SUNDRY NOTICES AND REPORTS ON WELLS
Do not use this form for proposals to drill or to re-enter an abandoned well. Use Form 3160-3 (APD) for such proposals.

8 Well Name and No
SKELLY UNIT #961

9 API Well No.
30-015-34324

SKELLY UNIT #961 DEEPENING PROGRAM

Centralizer Diagram

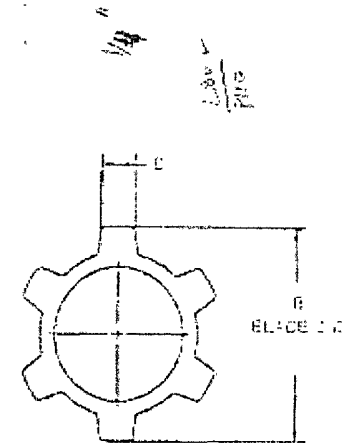
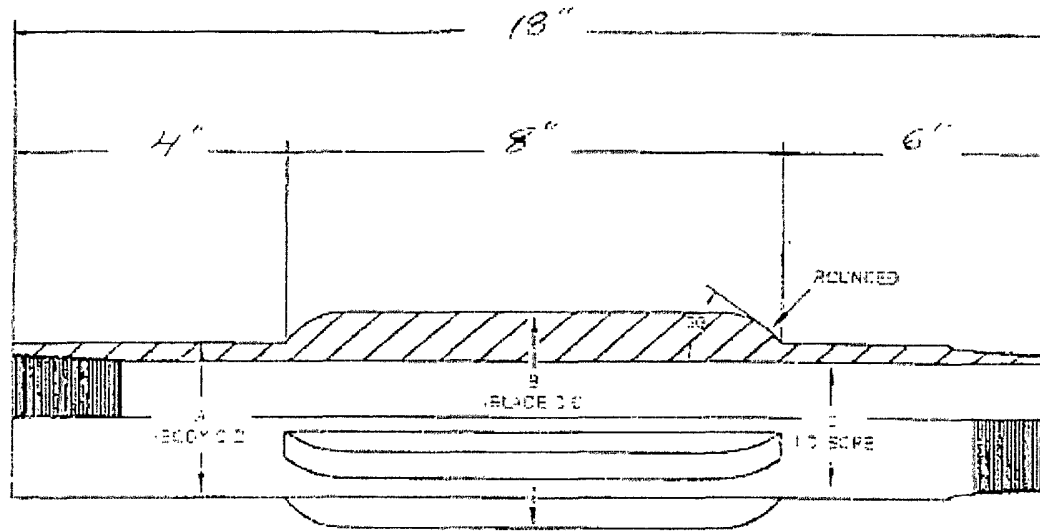
Fixed blade stabilizer subs will be utilized in the casing string to insure adequate isolation and seal throughout the wellbore. These stabilizer subs are positive fixed blade type. These subs will actually be screwed into the casing string. A diagram of the fixed blade stabilizer sub is located at the end of this program.

5. BOP to be tested to **1000 psi** based on BHP expected.
6. Variance for stand-off of less than 0.422" is approved due to NMOCD classifying the formations in this area as the Yeso group.
